DEPARTMENT OF ADMINISTRATIVE SERVICES

I-24-04

Request for Formal Interpretation of the 2022 Connecticut State Building Code

3 HR RATED FIRE WALL

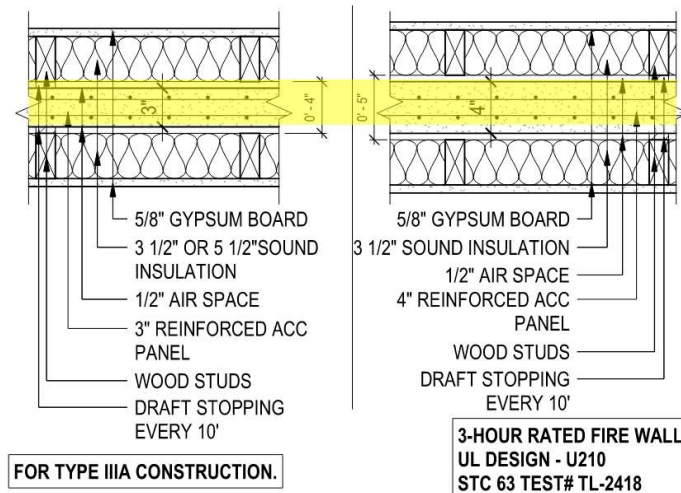
We have new 5-story Type III-A construction with an occupancy classification and use of R-2 proposed on top of a Type I-A construction podium which primarily serves parking. The problem we are seeking resolution to involves a conflict created by proposed use of wood framing in a UL U210 fire wall assembly (see attached) and the following from IBC:

706.3 Materials. *Fire walls* shall be of any *approved* noncombustible materials. **Exception:** Buildings of Type V construction.

Per the UL product iQ sheet for U210, which was revised on 3/08/2024, this assembly achieved up to a 4-hour rating with only a panelized autoclaved aerated concrete (PAAC) core. Per the emails with the architect, they are proposing the following, and our question to you is: Would you agree the proposed firewall conflicts with IBC section 706.3?

The 2021 International Building Code portion of the 2022 Connecticut State Building Code Section 703.2.1 Tested assemblies states that “a fire-resistance rating of building elements, components or assemblies shall be determined by the test procedures set forth in ASTM E119 or UL 263.” According to the *BXUV Guide Info - Fire-resistance Ratings - ANSI/UL 263: Design Information Section*, “only when constructed together as specified in the individual designs are all the requirements of UL 263 met for the assigned assembly rating.” As noted in the question above, IBC Section 706.3 requires that fire walls be constructed of “any approved noncombustible materials.”

Therefore, in UL design assembly U210 the studs are a required component of the assembly and are not listed as an optional material, and thus shall be of noncombustible material to be used in this particular instance and meet the requirements of IBC Section 706.3 for Type III Construction.
